ECE/TRANS/WP.29/GRSP/2007/17
28 September 2007

REGULATION No. 94
(Frontal collision)

Proposal for draft amendments

Proposal submitted by France^{*/}

Figure 1: Barrier dimensions.

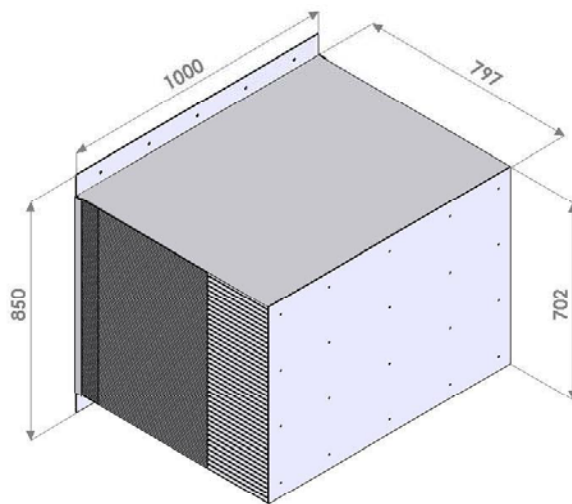
The PDB deformable barrier is a stacking of three deformable aluminium honeycomb cores. The first (front deformable core, 250 mm thick) is designed to provide a constant load in depth. The second (progressive deformable core, 450 mm thick) is designed to provide a progressive load in depth. The third (back deformable core, 90 mm thick) is designed to provide a constant load in depth. Aluminium honeycomb cores are bonded together with different aluminium sheets forming a ready to use deformable barrier to be fixed on a rigid wall.

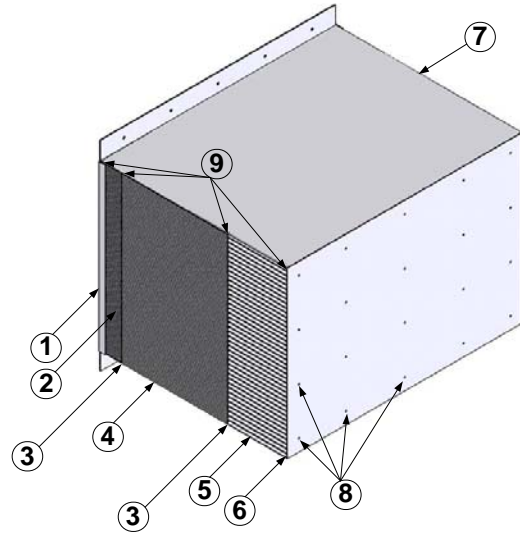
The PDB barrier is composed of the following components:

- (1) One back plate,
- (2) One back deformable core,
- (3) Two intermediate plates,
- (4) One progressive deformable core,
- (5) One front deformable core,
- (6) One contact plate,
- (7) One outer cladding,
- (8) Blind rivets,
- (9) Epoxy resin.

1.1. Back Plate geometrical and material characteristics (1)

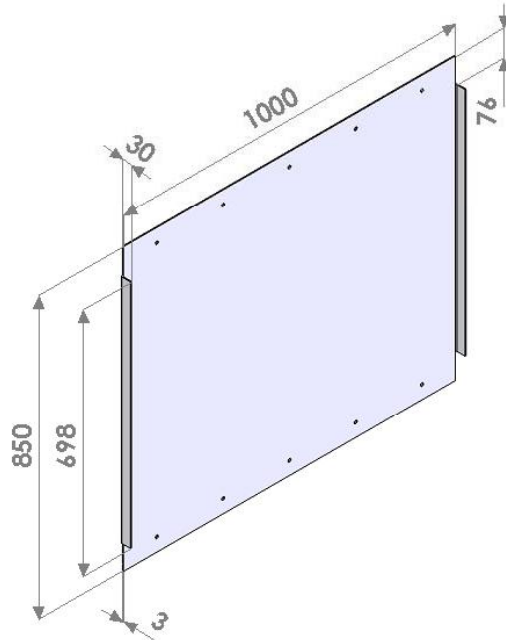
The back plate is 1000 ± 2.5 mm wide and 850 ± 2.5 mm high. The thickness is 3 mm. The back plate is manufactured from Aluminum of 1050A H14.

1.2. Intermediate Plate geometrical and material characteristics (3)

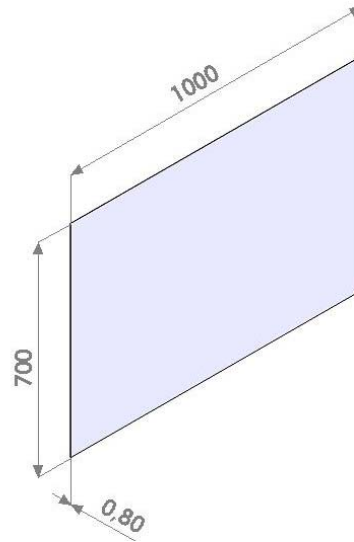
The intermediate plate is 1000 ± 2.5 mm wide and 700 ± 2.5 mm high. The thickness is 0.5 mm. The back plate is manufactured from Aluminum of 5754 H111.

1.3. Contact plate geometrical and material characteristics (6)

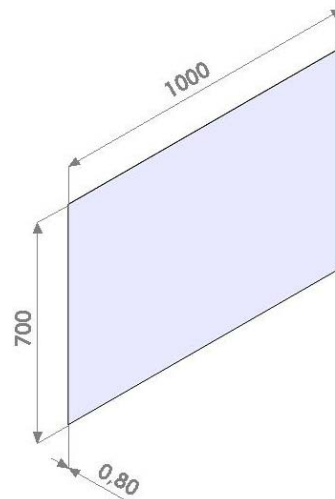
The contact plate is 1000 ± 2.5 mm wide and 700 ± 2.5 mm high. The thickness is 1.5 mm. The contact plate is manufactured from Aluminum of 1050A H24.

1.4. Cladding geometrical and material characteristics (7)

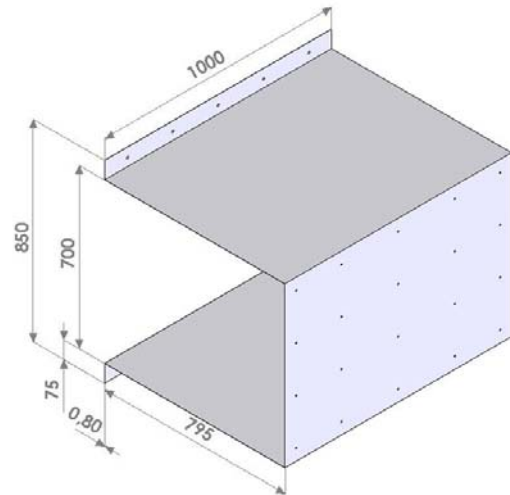
The cladding is 1000 ± 2.5 mm wide and 850 ± 2.5 mm high. The thickness is 0.8 mm. The cladding is manufactured from Aluminium of 5754 H22.

The cladding has two mounting flanges of 75 mm allowing rigid wall mounting. Twenty 6.2 mm holes shall be drilled through the outer cladding in order to accommodate front face blind rivets.

1.5. Rivets position (8)

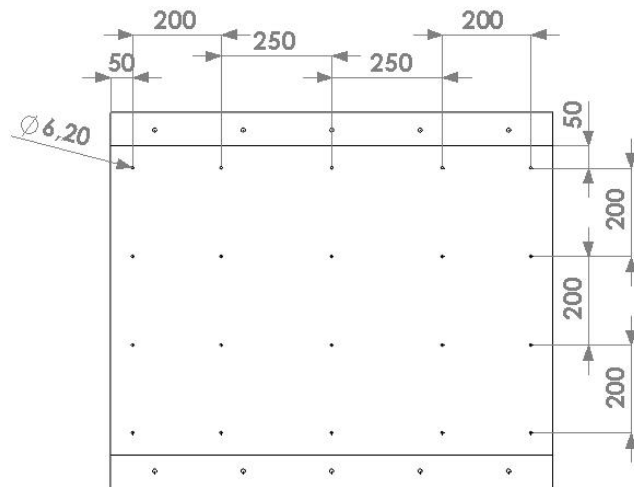
Twenty blind rivets shall be used to improve the link between outer cladding and contact plate. Rivets shall be aluminum/steel blind rivets diameter 6 mm.

1.7. Honeycomb deformable cores

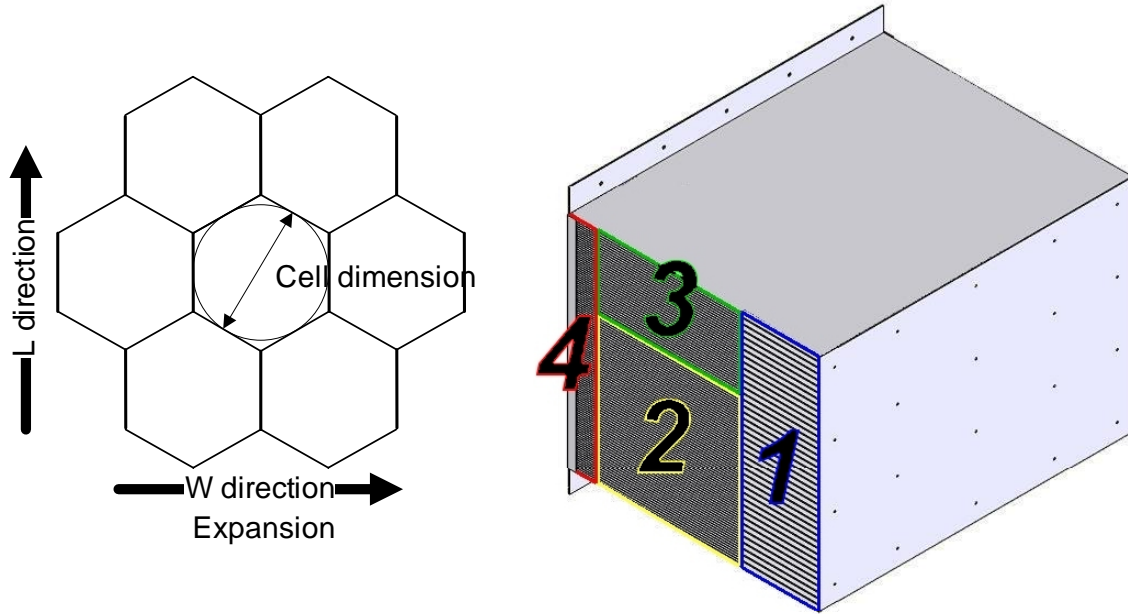
The PDB deformable barrier is a stacking of three deformable aluminium honeycomb cores and provides 4 different crushing strength areas (#1, #2, #3, #4) whose forms and positioning are shown below.

All honeycomb deformable cores shall be made of 3003 aluminium.

- (a) The cell dimensions for the front block shall be $19.1 \text{ mm} \pm 15$ percent.

- (b) The cell dimensions for the intermediate block shall be $9.5 \text{ mm} \pm 15 \text{ percent}$.
- (c) The cell dimensions for the rear block shall be $6.3 \text{ mm} \pm 15 \text{ percent}$.

1.7.1. Front block (5)

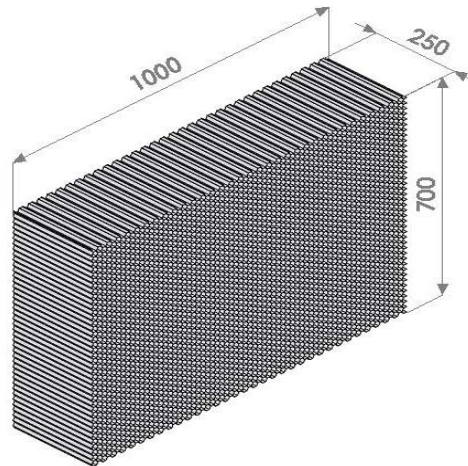
The front block (area #1) shall be $700 \pm 5 \text{ mm}$ in L Direction, $1000 \pm 5 \text{ mm}$ in W direction and $250 \pm 1 \text{ mm}$ in T direction. The crushing characteristics of the front block are constant.

1.7.2. Progressive block (4)

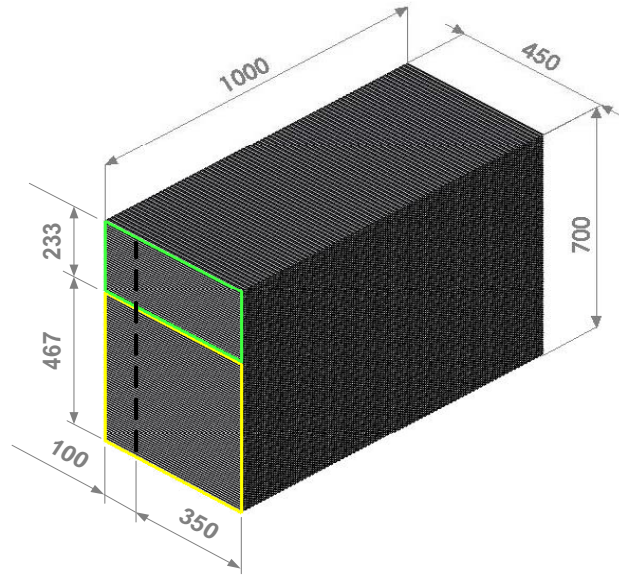
The progressive block (area #2 and #3) shall be: 700 ± 5 mm in L direction, 1000 ± 5 mm in W direction and 450 ± 1 mm in T direction. The crushing characteristics of the progressive block present 2 different load paths. The lower load path #2, offers a progressive resistance in depth for first 350 mm and a constant resistance in depth for last 100 mm. The upper load path #3, offers a progressive resistance in depth for first 350 mm and a constant resistance in depth for last 100 mm.

1.7.3. Back block (2)

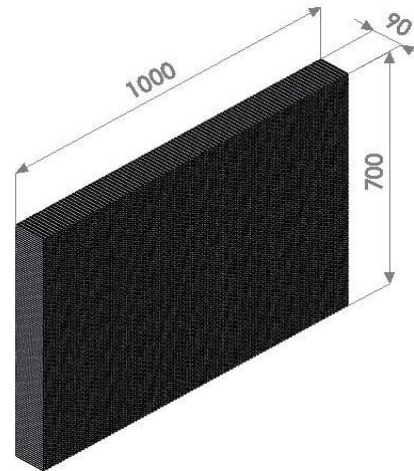
The back block (area #4) shall be 700 ± 5 mm in L direction, 1000 ± 5 mm in W direction and 90 ± 1 mm in T direction. The crushing characteristics of the front block are constant.

Figure 2: Crush strength specification for the different cores.

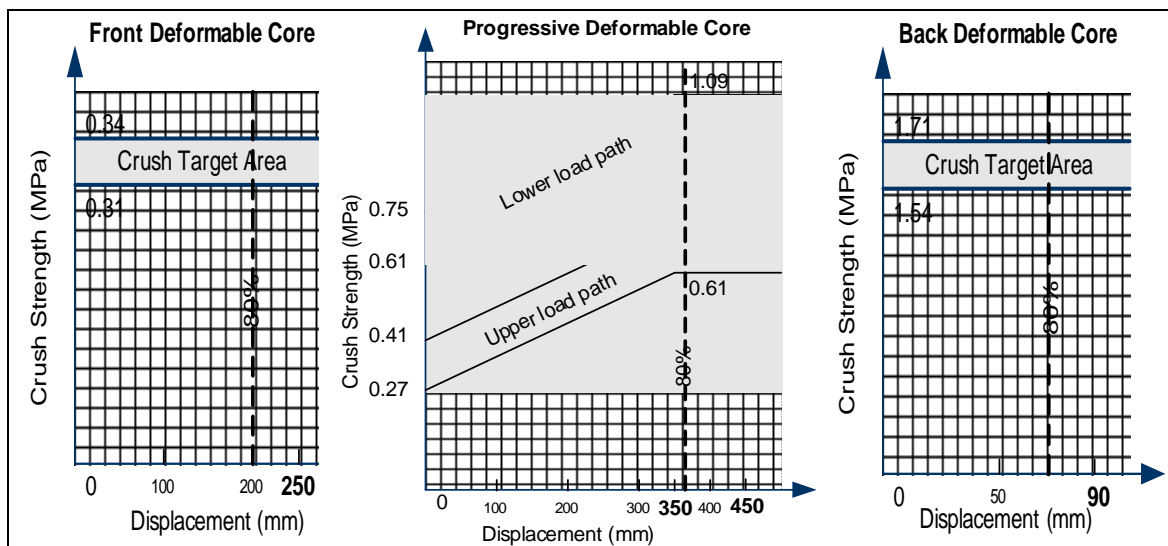
The crush resistance curve for each block tested shall be included within the corridors defined below:

Figure 3: Gluing detail among the different parts.

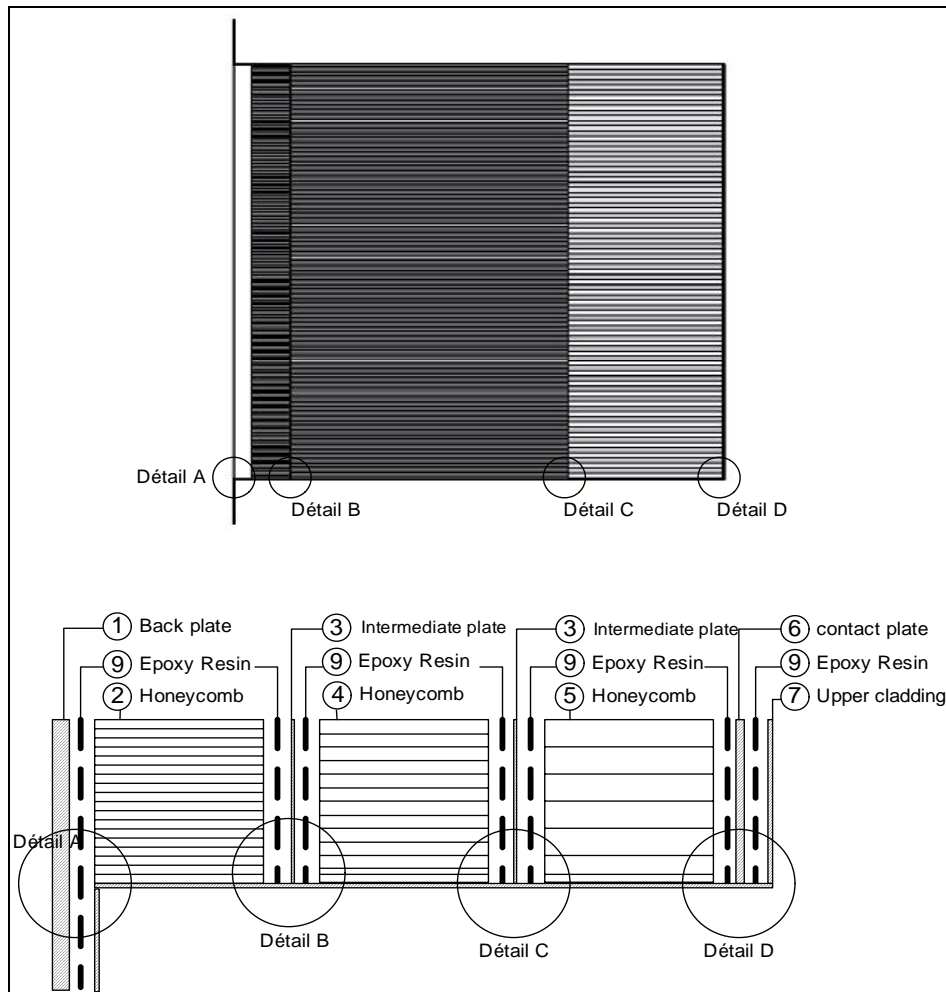
3.2. The adhesive should be applied to one surface only. In cases where honeycomb is to be bonded to aluminum sheet, the adhesive should be applied to the aluminum sheet only. A maximum of 0.5 kg/m^2 shall be applied evenly over the surface, giving a maximum film thickness of 0.5 mm.

- 4.1. The ~~main~~ honeycomb blocks shall be bonded to the sheets with adhesive such that the cell axes are perpendicular to the sheets. The **outer** cladding shall be bonded to the **contact plate**. The **upper** and **lower** surfaces of the outer cladding sheet shall not be bonded to the honeycomb blocks but should be positioned closely to it. The cladding sheet shall be adhesively bonded to the back plate at the mounting flanges.

Figure 5

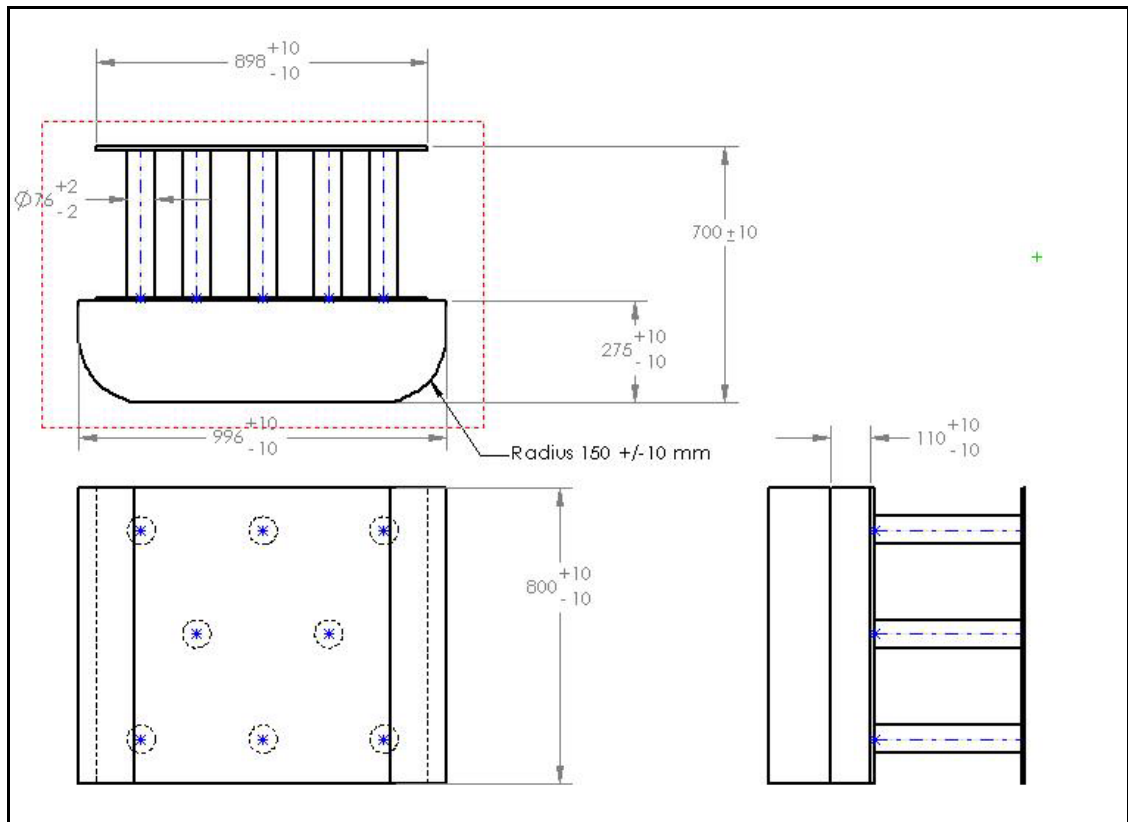
- 6.1.3.2. The angle between the longitudinal axis of the rigid wall and the direction of motion of the trolley shall be $0^{\circ} \pm 2^{\circ}$.
 - 6.1.3.3. The impactor consists of a rigid block defined in Figure 5. The material of the impactor must be in steel. The geometry of the impactor must respect the design in Figure 5.

Figure 6

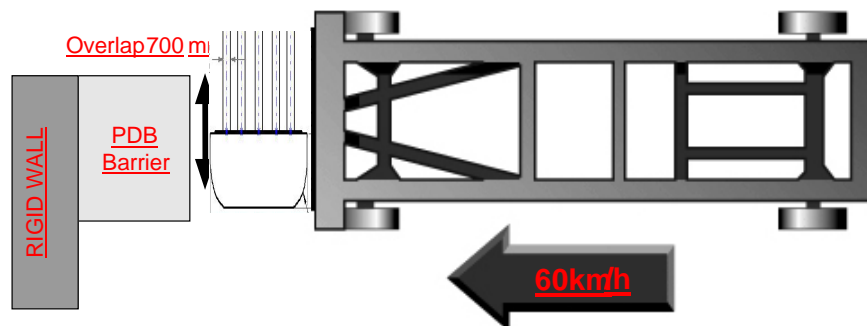
- 6.1.5.1. The rigid wall shall overlap the right side of the barrier face by 700 ± 20 mm in Y axis (Figure 6).
 - 6.1.5.2. The velocity of the trolley at the moment of the impact shall be 60 km/h $-0/+1$ km/h. If the test was performed at a higher impact speed and the test results meet the requirements, the test shall be considered satisfactory.

Figure 9

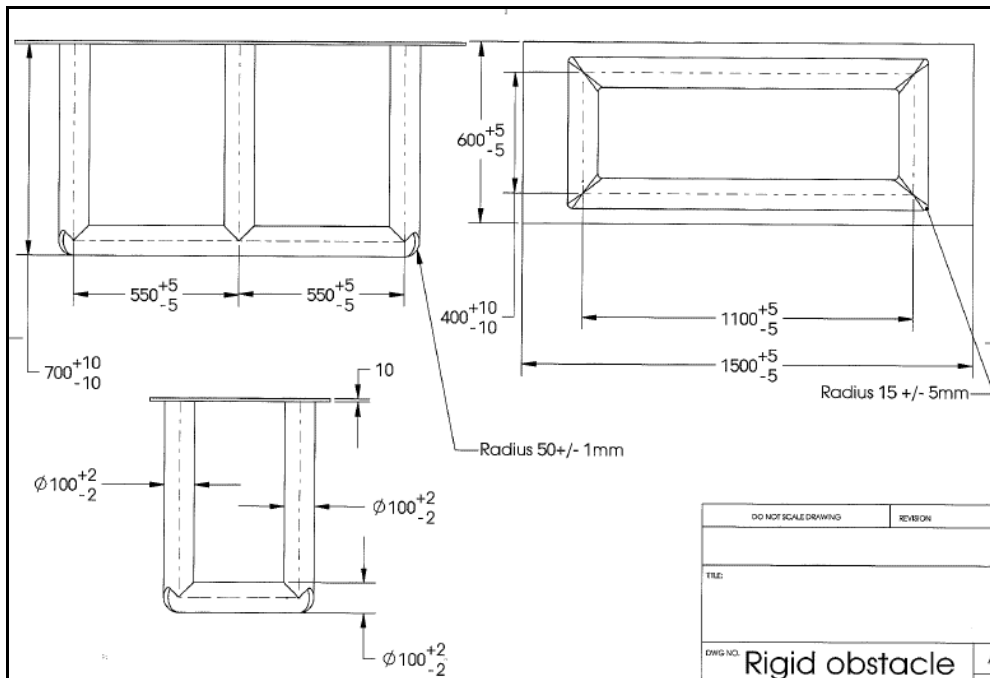
6.2.3.3. The impactor consists of a rigid block defined in Figure 9. The material of the impactor must be in steel. The geometry of the impactor must respect the design in Figure 9.

Figure 10

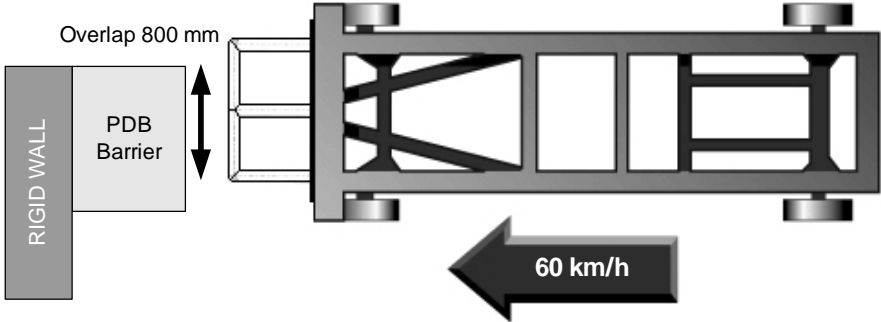
6.2.5.1. The rigid wall shall overlap the right side of the barrier face by 800 +/- 20 mm in Y axis (Figure 10).

Figure 1: Relative position area of side members and lower load paths in front of the barrier. Source: VC-Compat structural database.

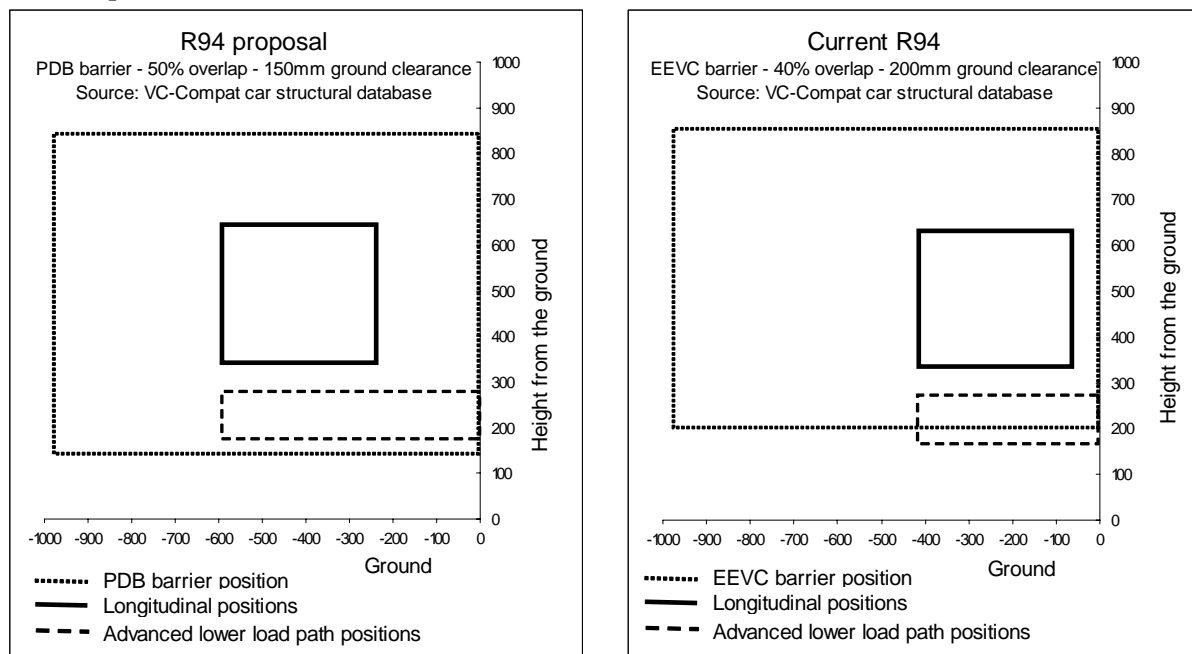
The 50 per cent overlap and 150 mm ground clearance ensures that the full front of the vehicle is in direct contact with the barrier when tested in offset conditions. Figures 1 below was realised with data collected in the Structural database of the "Vehicle Crash Compatibility" project (VC-Compat) validated by EEVC WG15 and presented on informal document GRSP-41-25 (41st GRSP session) and the document "presentation of the status report of EEVC WG15 activities" (38th GRSP session).

The 50 per cent overlap associated with the 150 mm ground clearance represents a minor change in terms of dynamic and kinematics, but a huge improvement for evaluating front-end design. In this position, the barrier is now able to check the stability of all main load paths (side members, cross members, cradle sub frame, blocker beam, advance lower load paths etc.) and all vehicle architectures (body on frame, longitudinal engine etc.).

Figure 2: Influence of the test speed and barrier design on the test severity for a vehicle mass.

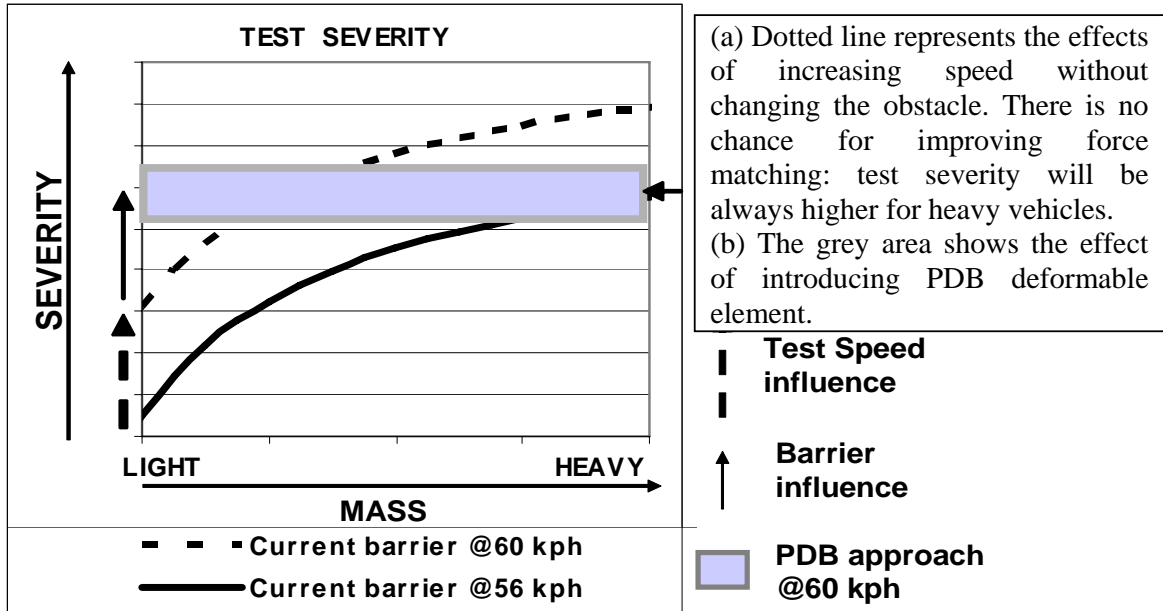
The PDB test is an overlap offset test at 60 km/h. The barrier stiffness increases with crush depth and also provides different force deflection characteristics in the upper and lower sections of the barrier. The PDB barrier was designed to harmonize the test severity among vehicles of different masses (Figure 2); it will encourage lighter vehicles to be stronger without increasing the force levels of heavy vehicles (Figure 3) that lead to better force matching, first step towards compatibility. Furthermore, the dimensions and stiffness of the PDB make the bottoming-out phenomenon very unlikely. The barrier face is capable of generating sufficient differential deformation of the weak and stiff parts of the car's front structure to replicate what happens in most accidents. This will encourage future car designs to incorporate structures, which distribute the force on a large surface better for structural interaction and partner protection. Its potential for harmonisation is important.

The combination of higher test speed and the introduction of the PDB barrier introduction increase the test severity for light vehicles without changing heavy one's. Test severity for all vehicle mass range will be harmonised.

Figure 3: Force level tendency to meet self-protection requirements vs. vehicle mass.

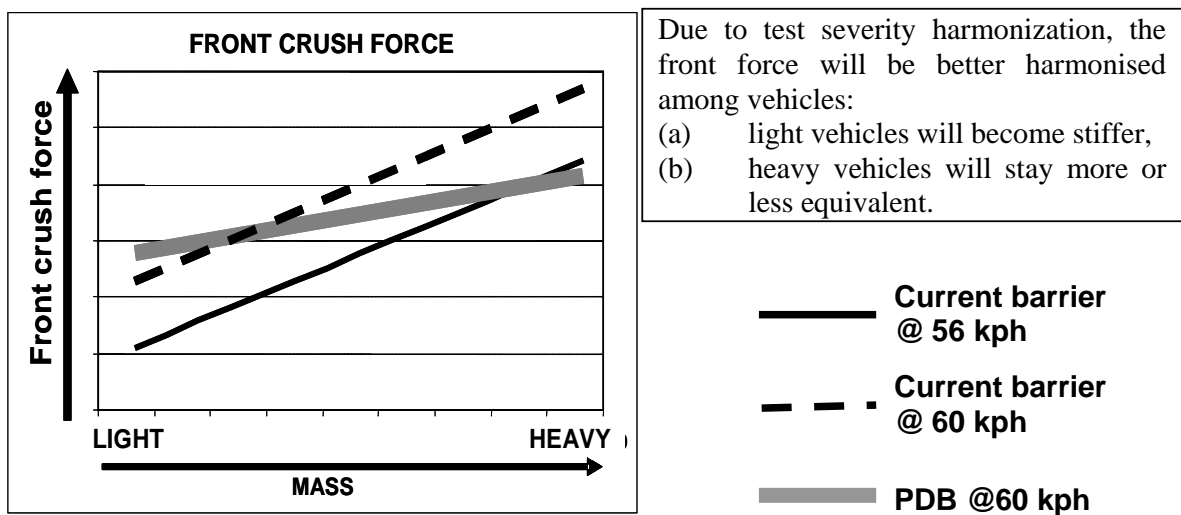
According to the previous figure 2, light vehicles will be designed with the same self-protection level as the heavy one. The increase of frontal force levels of heavy vehicles will be stopped and the compartment strength of the light vehicle will be reinforced. The concept of force matching will be reachable.
